**Demolition on Park Property at 15210 Peach Orchard Road**

**\*A. Preliminary/Final Water Quality Plan MR2014001:  
Demolition on Park Property at 15210  
Peach Orchard Road, Parcel P385**

**B. Mandatory Referral No. MR2014001: Demolition on Park  
Property at 15210 Peach Orchard Road, Parcel P385**

**TITLE**  
**SPA WATER QUALITY PLAN FOR DEMOLITION AND REMOVAL OF IMPERVIOUS SURFACE AT 15210 PEACH ORCHARD ROAD IN SILVER SPRING (Parcel P385)**

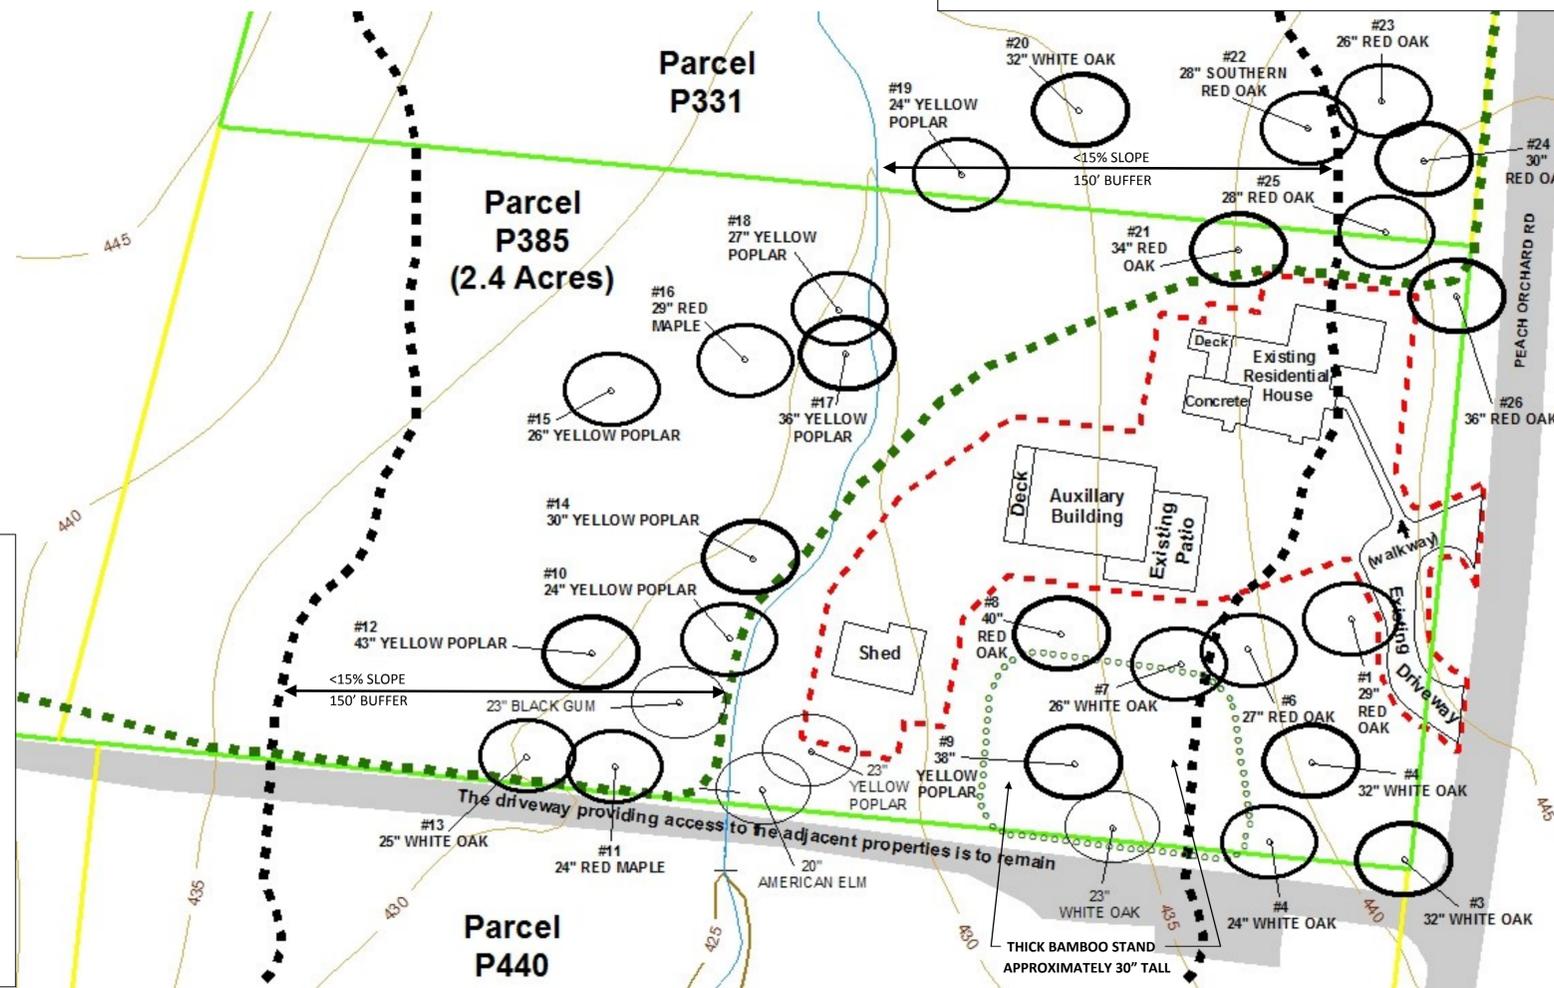
2. The Applicant must remove all impervious surfaces as shown on the preliminary/final water quality plan dated August 20, 2013. Any existing pavement that is maintained as part of Peach Orchard Road that may be within the Property boundaries must remain.

3. The Applicant must submit a plan that provides specifications for reclamation to stable, pervious surfaces of areas where impervious surfaces had existed. The reclamation plan must reference a scaled plan that shows the proposed limits of disturbance, features to be demolished or removed, and existing stream, trees, and forest cover that is within 50 feet of the proposed limits of disturbance. The reclamation plan must be submitted to the Staff of the Planning Department for review and approval prior to the pre-work meeting.
